4 Project changes and design refinements

The EIS for the project was prepared based on a concept project design (refer Chapter 5 of the EIS). This design has since been refined to account for design changes and in response to submissions received during exhibition of the EIS.

The Northern Road upgrade -
Mersey Road to Glenmore Parkway
**Construction Boundary and
Compound Sites**

JACOBS NSW SPATIAL - GIS MAP file : IA086100_TNR456_PostEISConstBoundary_EISConstFootprint | 18/10/2017 | DRAWN BY: AA

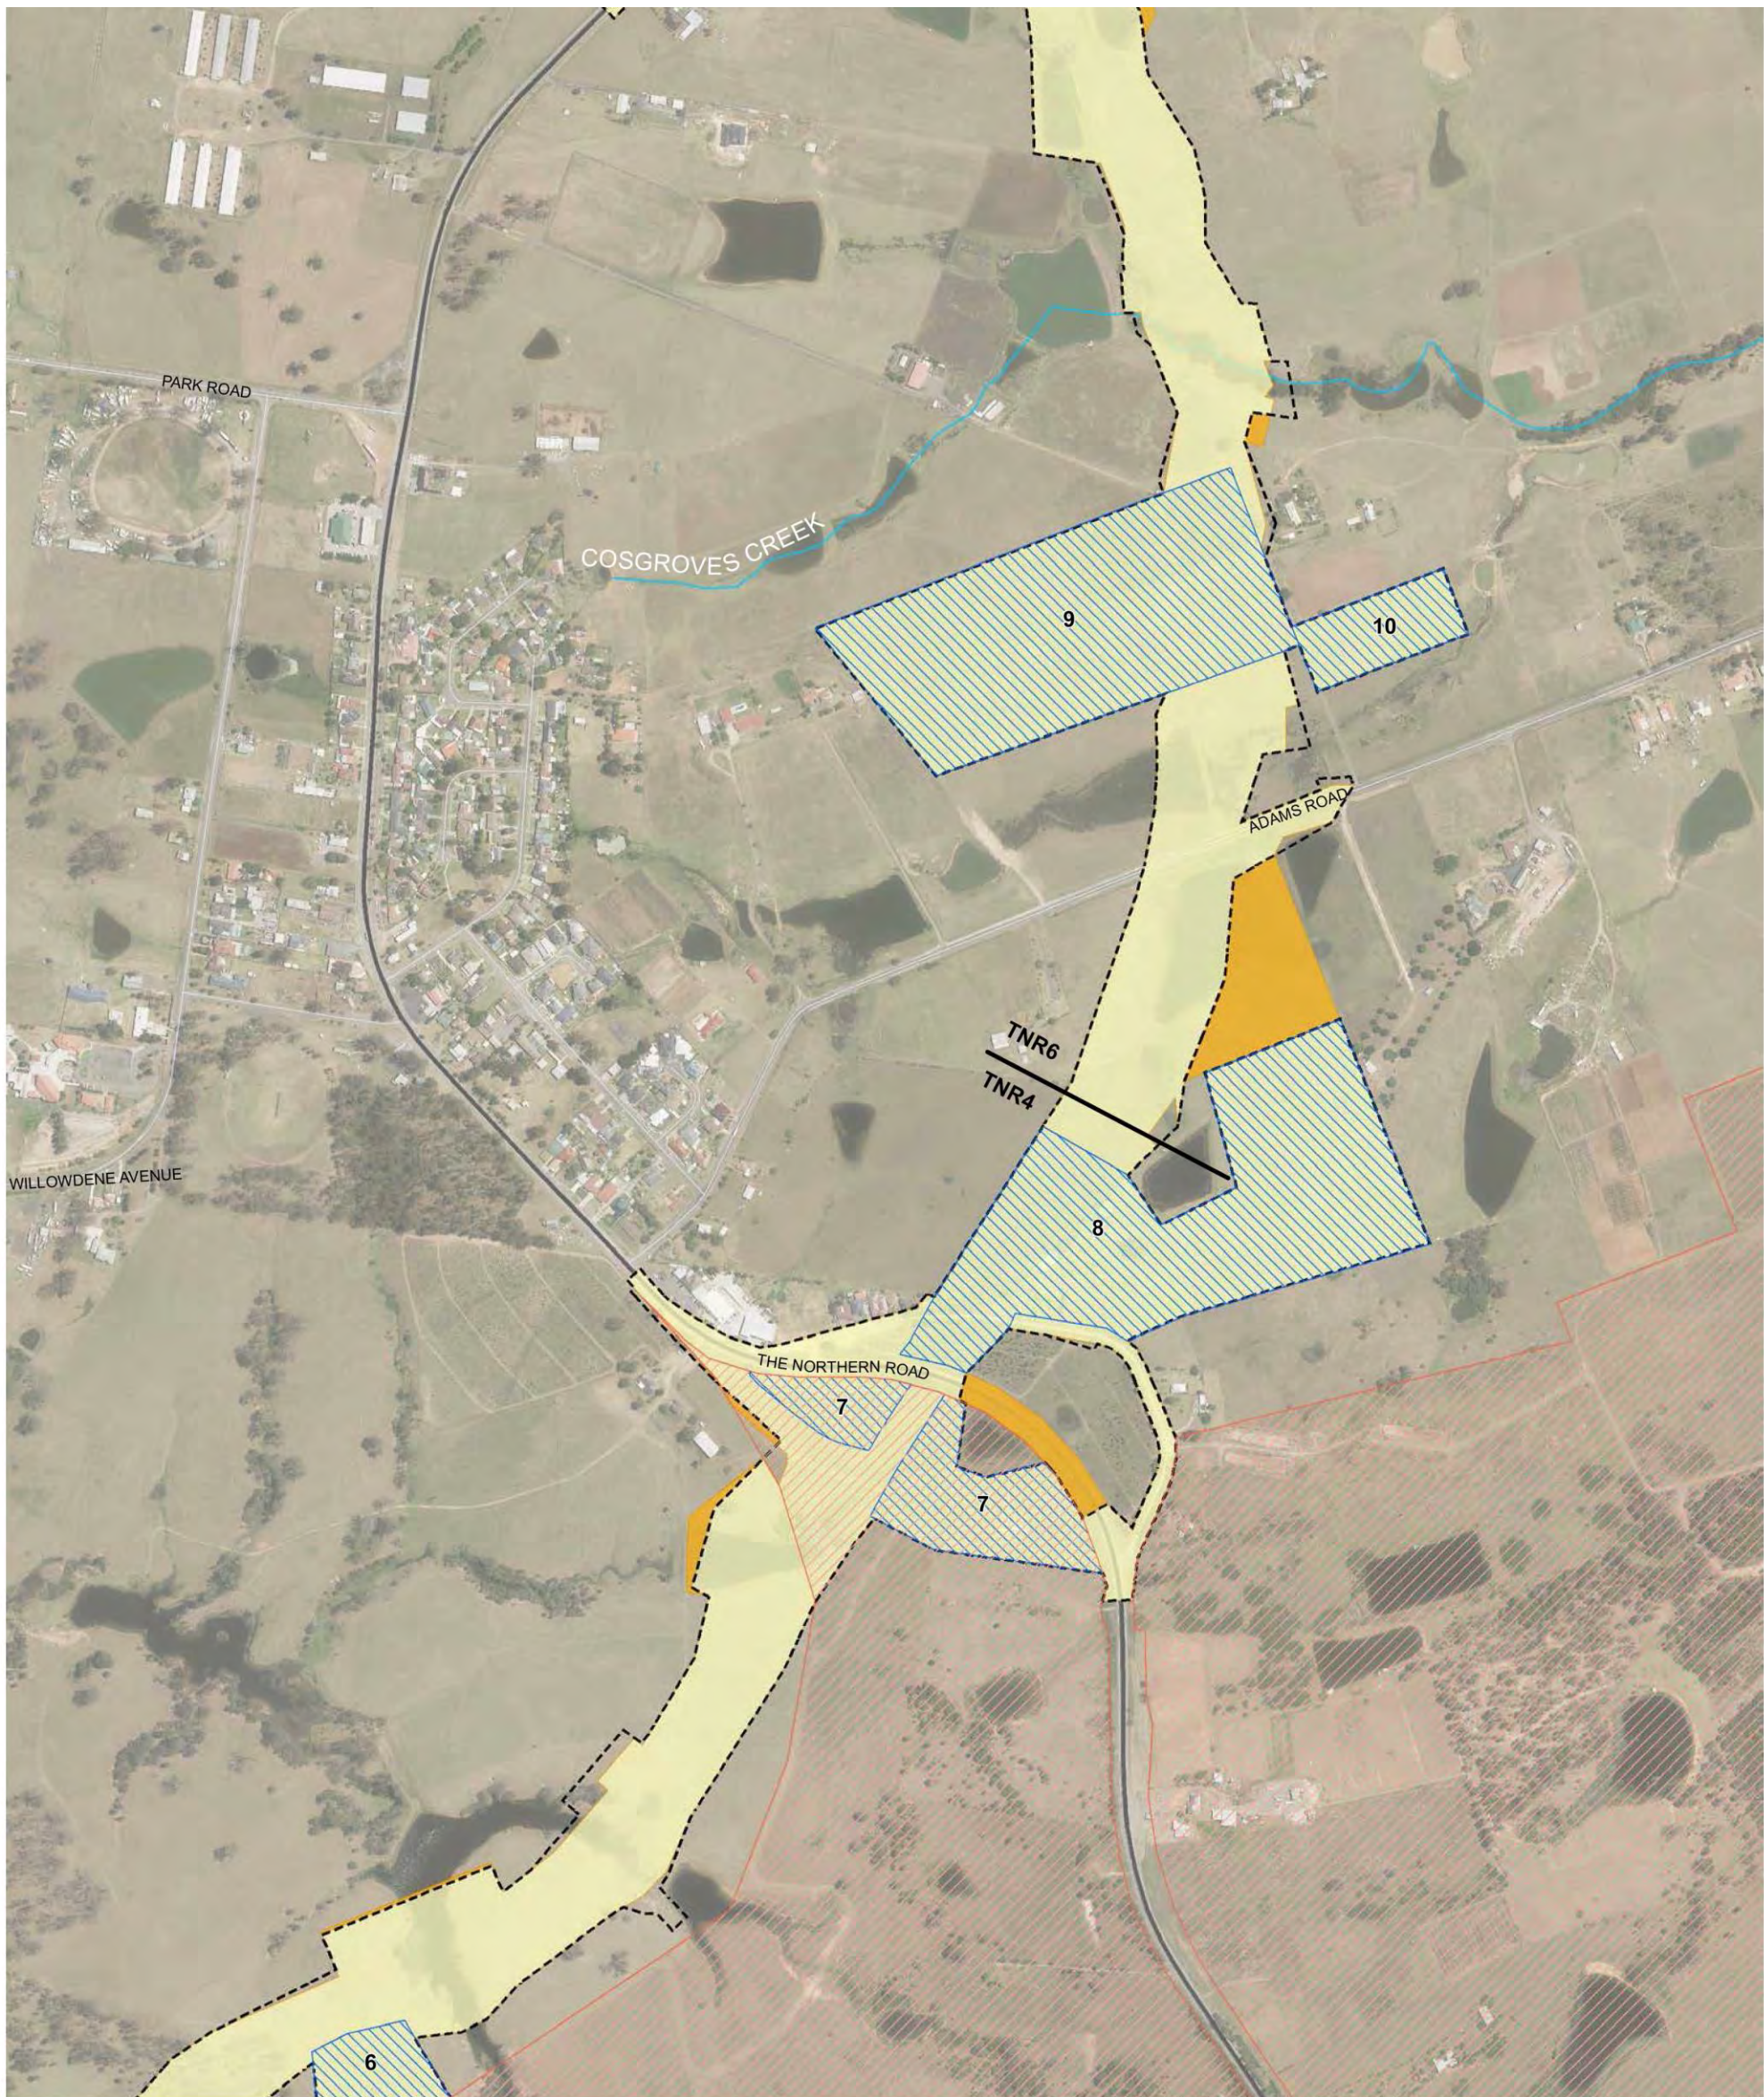
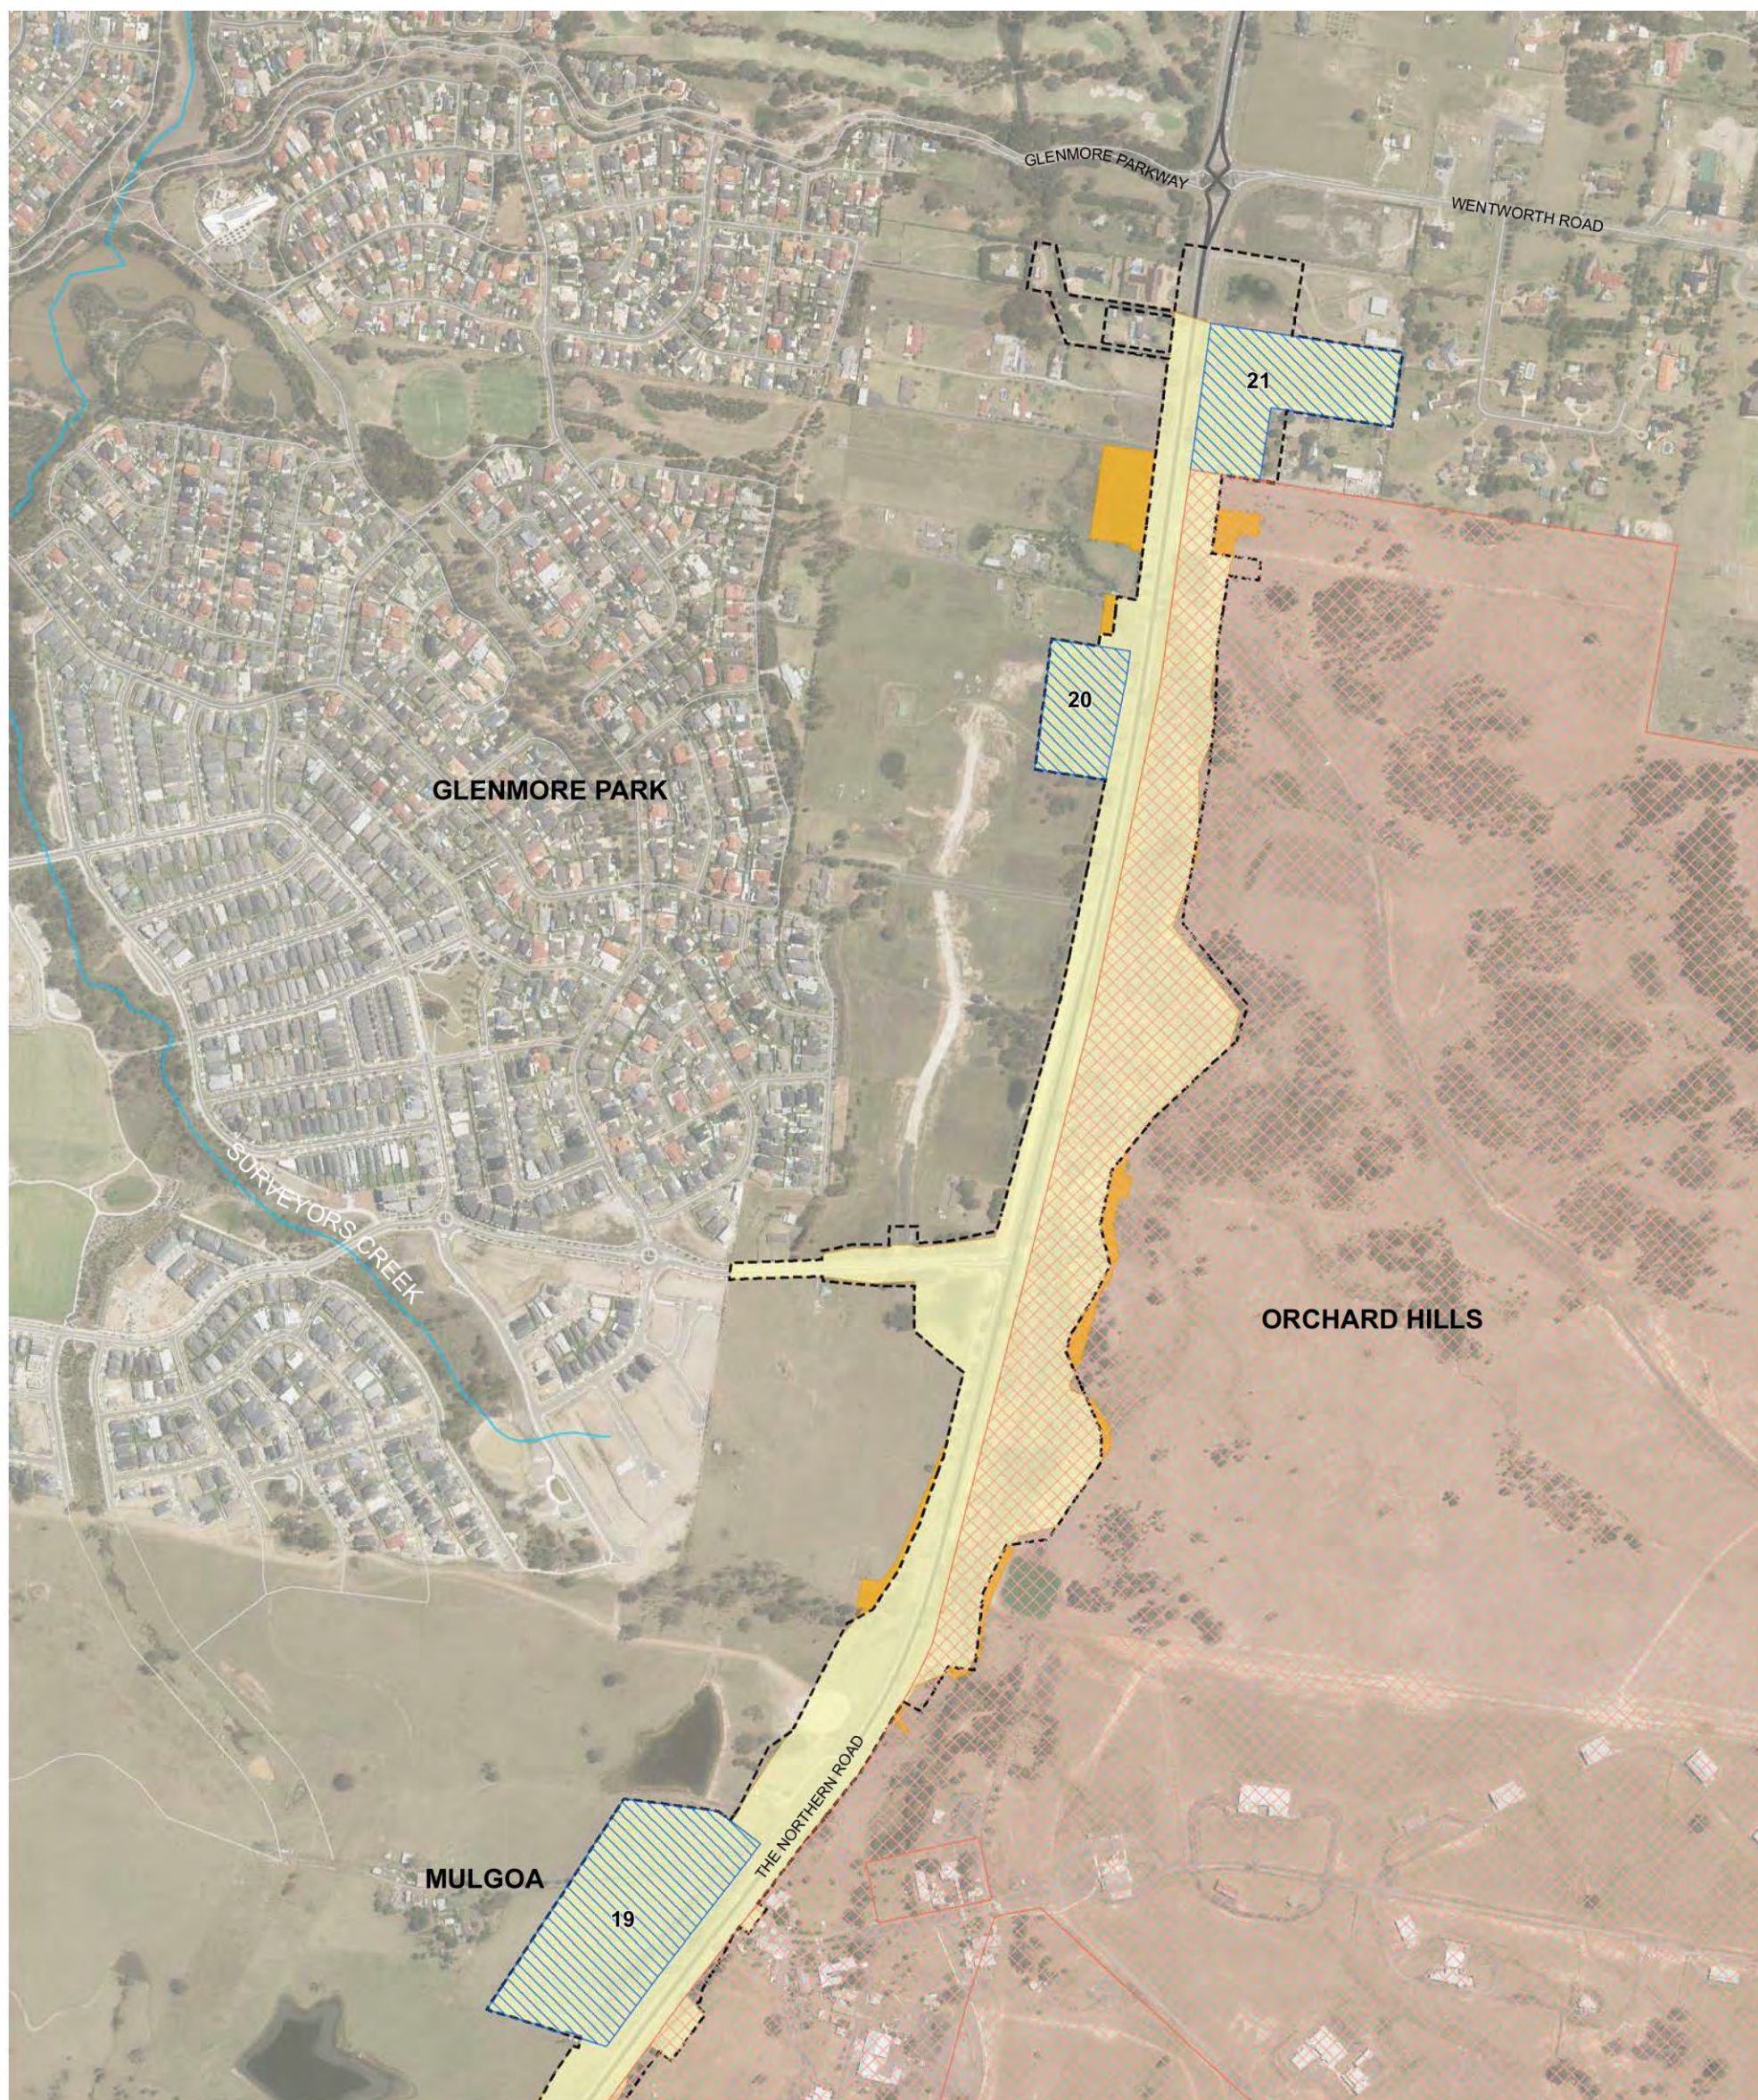
Table 4-2 provides a comparison of the construction and operational footprints calculated for the design refinements against the footprints assessed in the EIS, with reductions of 10 ha and 16 ha identified respectively. An error in the EIS footprint calculations (EIS – original) was identified during the footprint assessment which has been corrected in the table (EIS – revised).

Figure 4-2 provides a comparison of the EIS and the refined design construction footprints. Figure 4-3 provides a comparison of the EIS and the refined design operational footprints.
